Amendment 108 to Local Planning Scheme No. 3 - Proposed Rezoning of Lot 32 (4) Kirkdale Road and Lot 33 (4) Orange Valley Road, Kalamunda

SUBMISSION TABLE

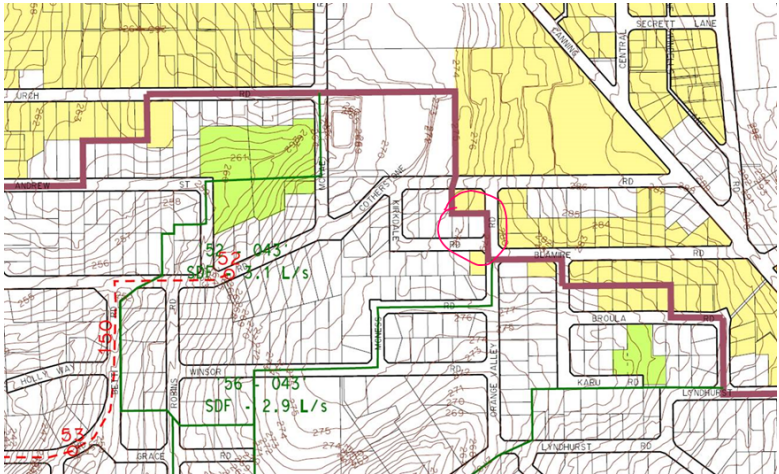
<p>and sewer grades, the Corporation would consider taking a small amount of flow into the network.</p> <p>Any approved extensions of the Water Corporation reticulation network would be customer funded.</p>  <p>The map displays a topographic area with contour lines and a proposed water reticulation network. Key features include:         <ul style="list-style-type: none"> <li>Flow rates: 0.43 L/s (green text), 2.9 L/s (green text), and 5.3 L/s (red text).</li> <li>Street names: SECRETY LANE, CENTINA, BLANCK RD, BROADWAY, WINSOR, GRACE, LYNDHURST, KABU, BROULA, and LYNDHURST RD.</li> <li>Flow directions: Indicated by red arrows and dashed lines.</li> <li>Flow into the network: A red dashed line labeled '5.3 L/s' indicates flow into the network from the left.</li> </ul> </p>	<p>The consulting engineer drawings were included in the attachments of the council report to initiate advertising. Following further correspondence, it is understood, more detailed designs at the subdivision/ development stage would be required to determine if the proposed concept design would be adequate. It is noted a small amount of flow into the network maybe supported.</p>
